SERVICE BULLETIN

CHECKING OR REPLACEMENT OF THE EXHAUST BEND ON ROTAX[®] ENGINE TYPE 914 (SERIES) SB-914-017

MANDATORY

Bild / Fig. 1

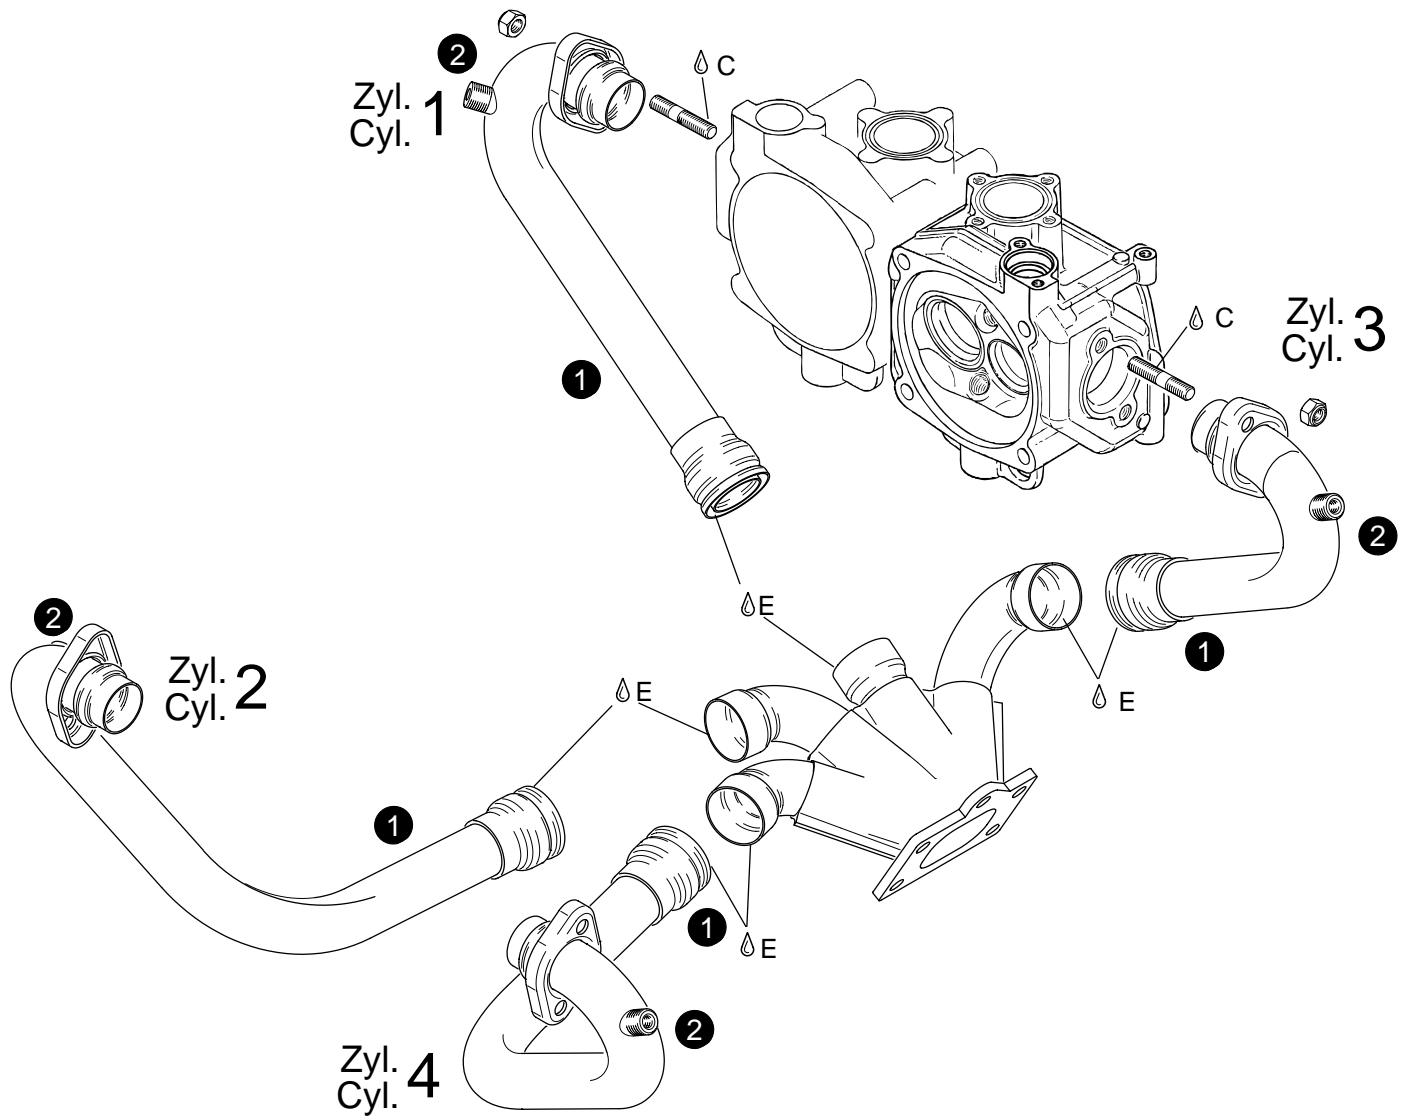
- Inspect the exhaust bends (1) in accordance with the relevant Maintenance Manual.

◆ **NOTE:** Scrutinize the exhaust bends for exterior traces of smoke, cracks and other faults especially about the EGT-terminals (2). See fig. 1.

- If cracks are detected replace the exhaust bend in accordance with the relevant Maintenance Manual.
- Reconnect negative terminal of aircraft battery.
